ADDENDUM #1

28 FEBRUARY 2017
NUMBER OF PAGES:

GALENA FIRE DEPARTMENT – FIRE STATION RAMP PROJECT - Bid date: 7 March 2017

SHEET
2 OF 4

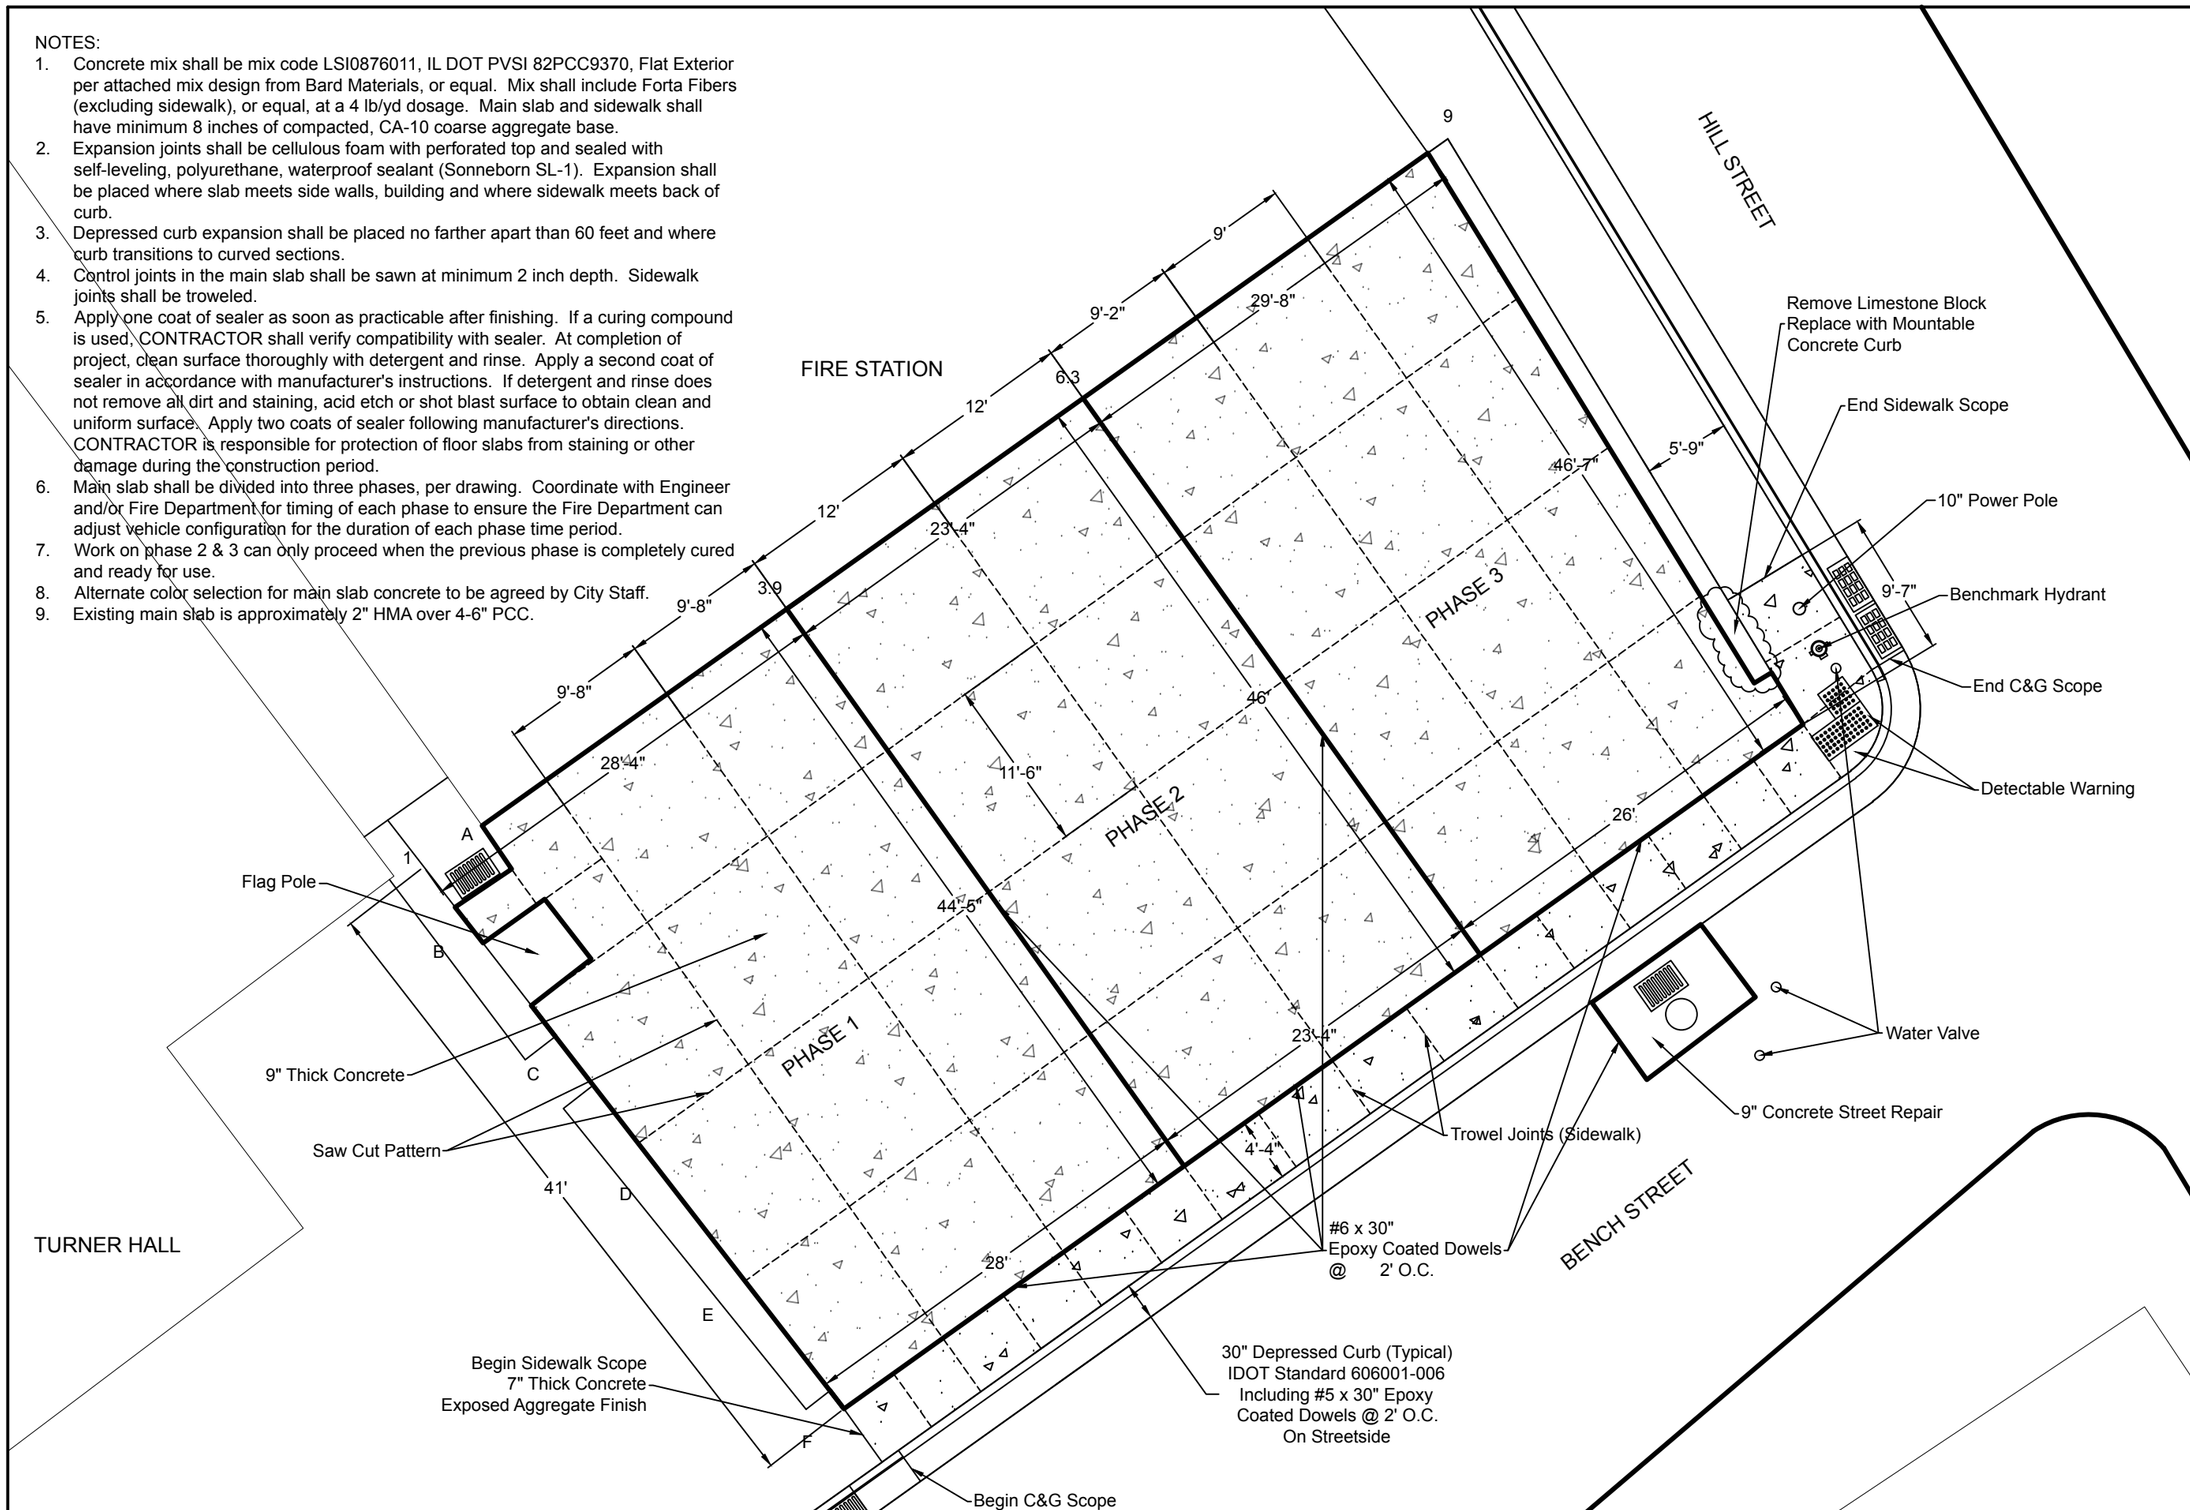
8. See updated Sheet 2 and Sheet 4 of drawing set for further details.
